Fortune Minerals Limited NICO Cobalt-Gold-Bismuth-Copper Project

Information Request Responses

Mackenzie Valley Review Board 200 Scotia Centre PO Box 938 Yellowknife, NWT, X1A 2N7 Canada

Report Number: 09-1373-1004 **December 2011**

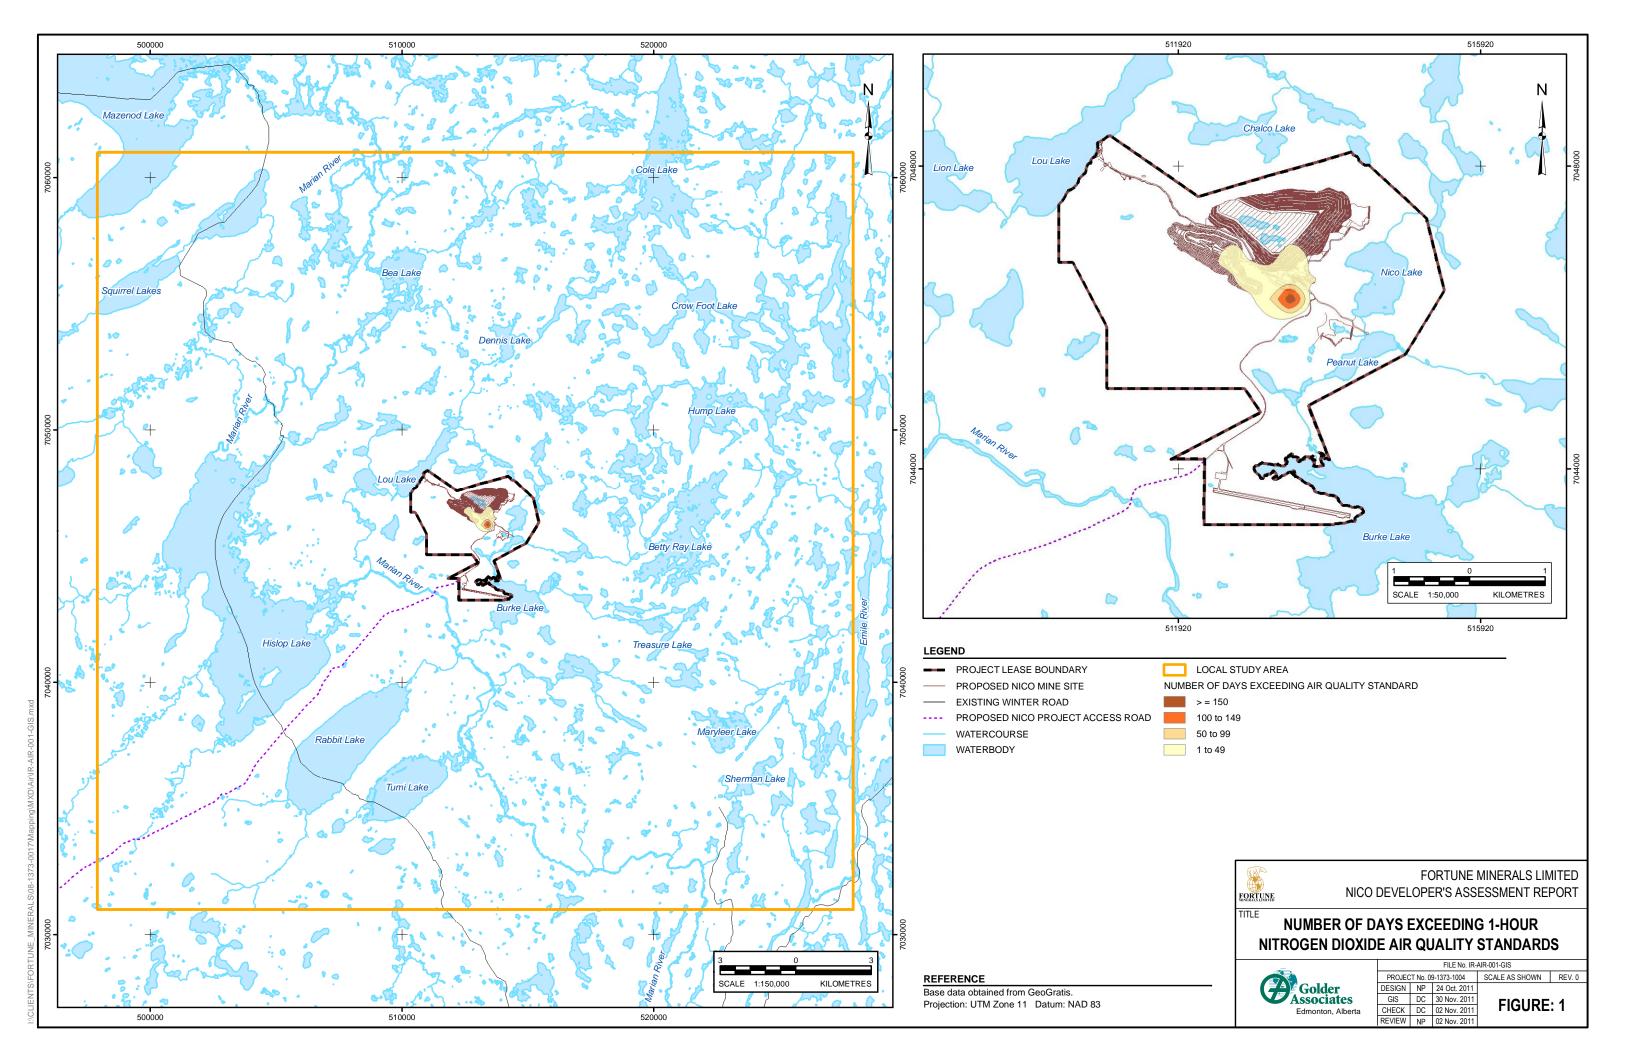
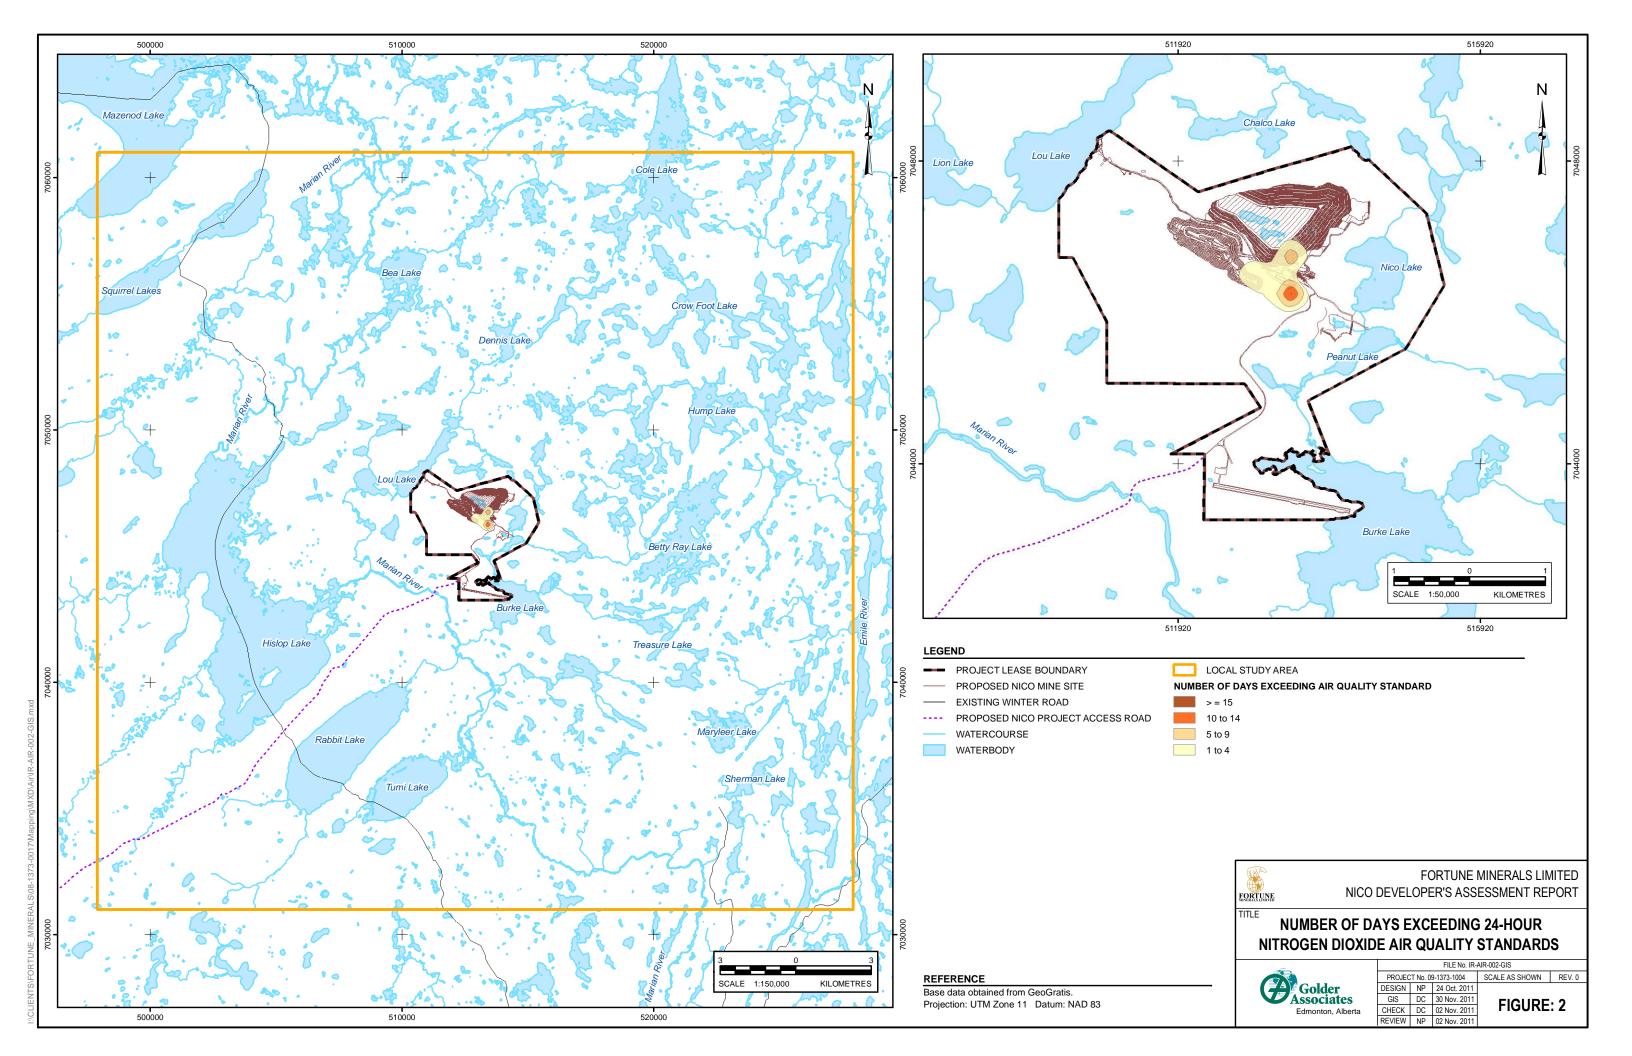
- 1) Please provide estimates of the spatial extend of the predicted exceedances of ambient air quality standards within and outside of the mine lease boundary.
- 2) Please provide frequency of exceedance plots for NO₂, which are similar to the plots provided for TSP (figure 10.4-12) and PM_{2.5} (figure 10.4-9).
- 3) Please provide details of an ambient air quality monitoring plan to address the predicted exceedances.

Frequency of exceedance plots are shown in Figures 1 and 2 for predicted 1-hour and 24-hour NO_2 concentrations, respectively.

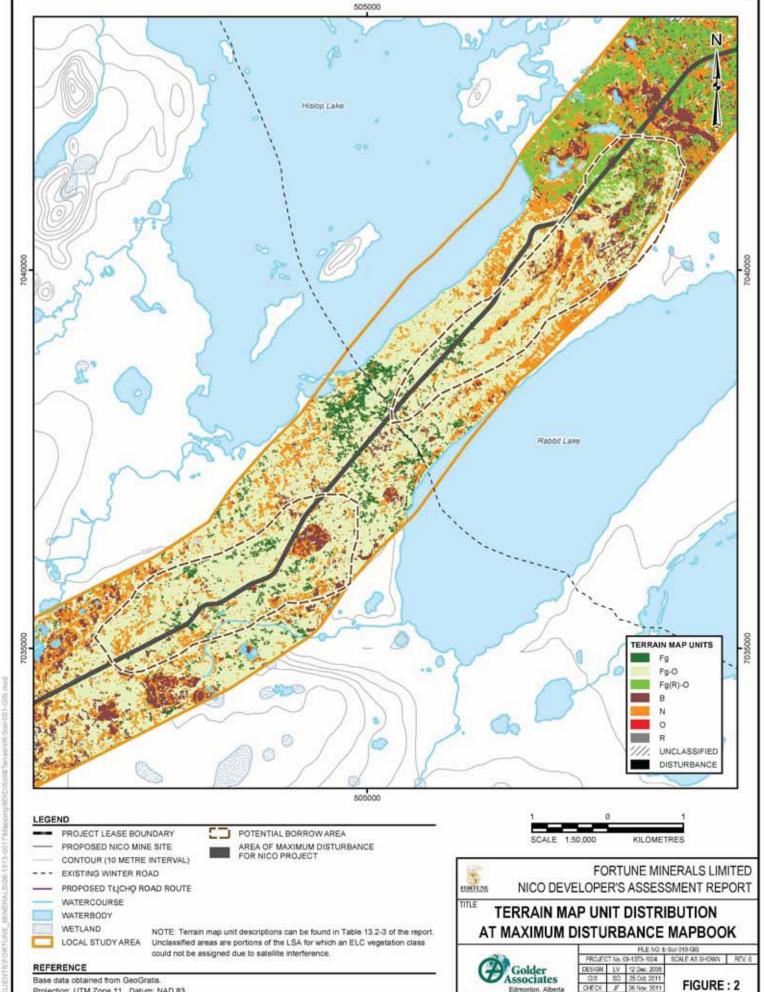
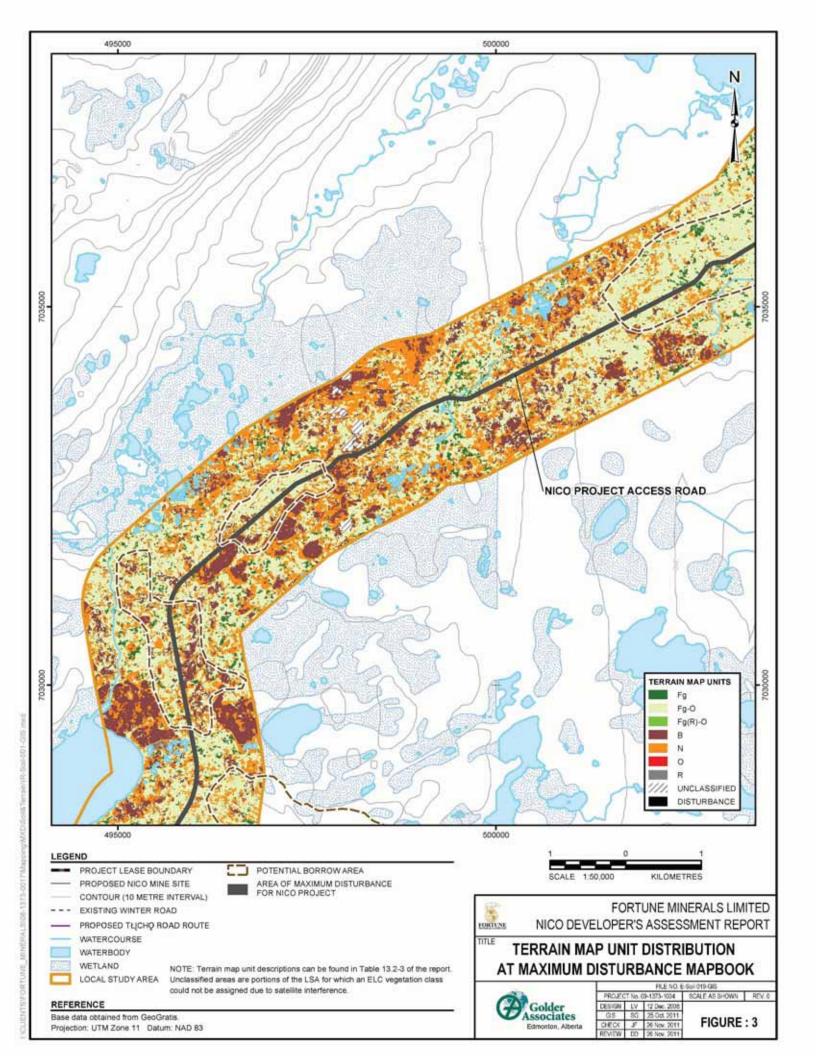
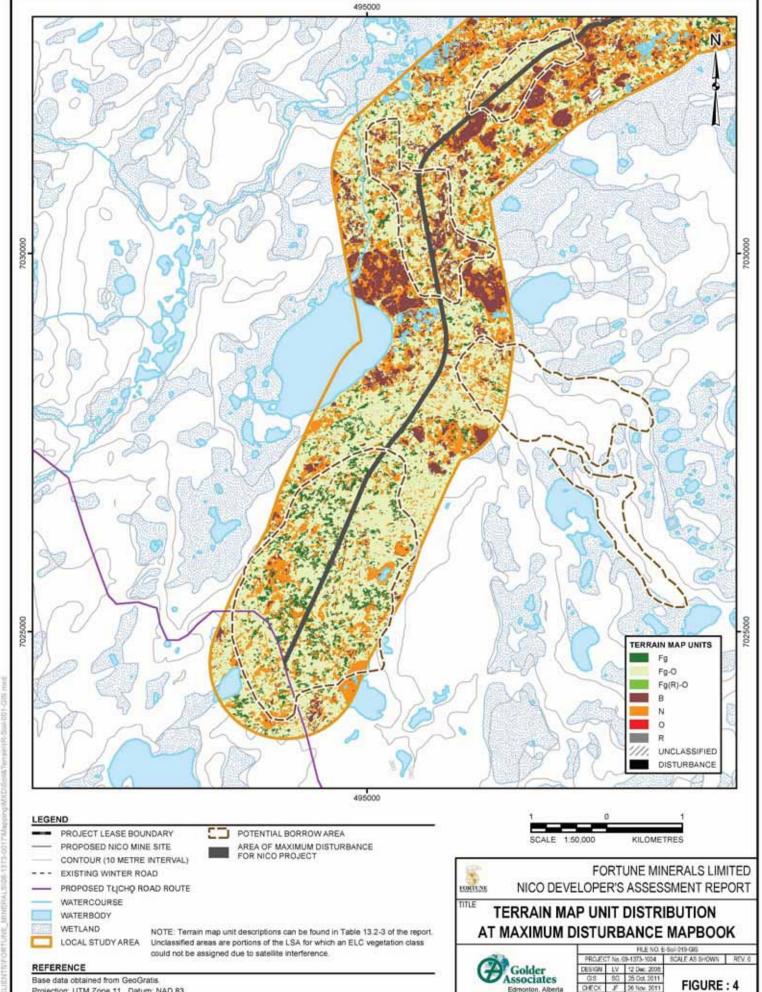
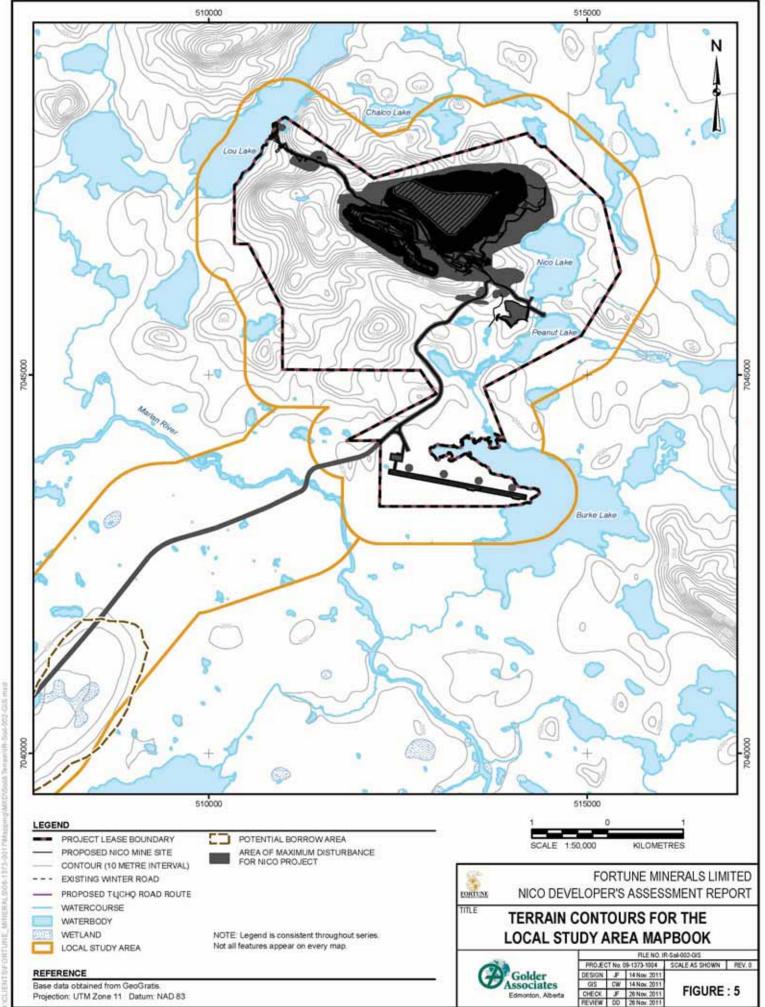
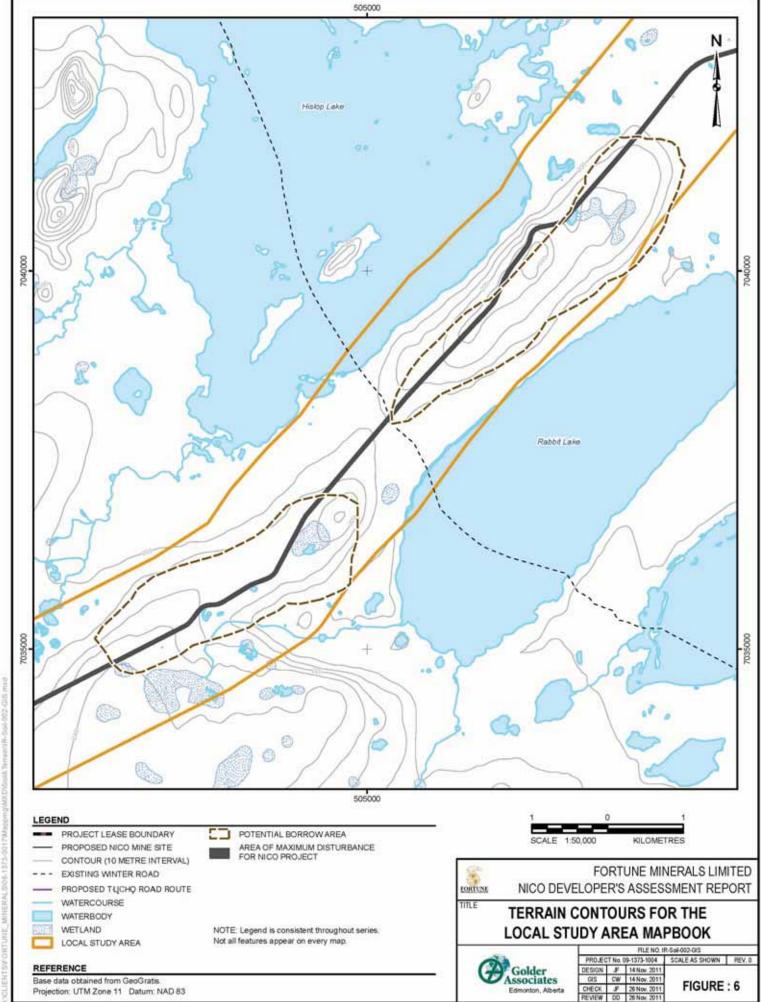
- i) explain why no suitable ground verification was conducted to confirm the remote predictive terrain mapping, and, if such verification is planned, when it will occur.
- ii) provide maps of terrain units within and surroundings some of the potential borrow areas indicated on Figure 13.4-1b.
- provide the locations of fine grained lacustrine/glaciolacustrine sediment on terrain maps. Confirm if the extent of this materials may be greater than anticipated between 200-300 masl.

A large scale route alignment map showing terrain types along the NICO Project Access Road (NPAR) can be found in Figures 1 to 4. Locations of watercourse crossings and contour lines are shown on Figures 5 to 8.

Terrain sensitivity conditions were determined for each terrain map unit occurring along the NPAR. Terrain sensitivities (freeze and thaw stability) were assigned to each terrain map unit based on soil drainage and texture. Thaw induced displacement includes thaw settlement and thaw slumping; Freeze induced displacement includes frost heave and frost creep. In general, as moisture content increases, the freeze and thaw stability decreases.
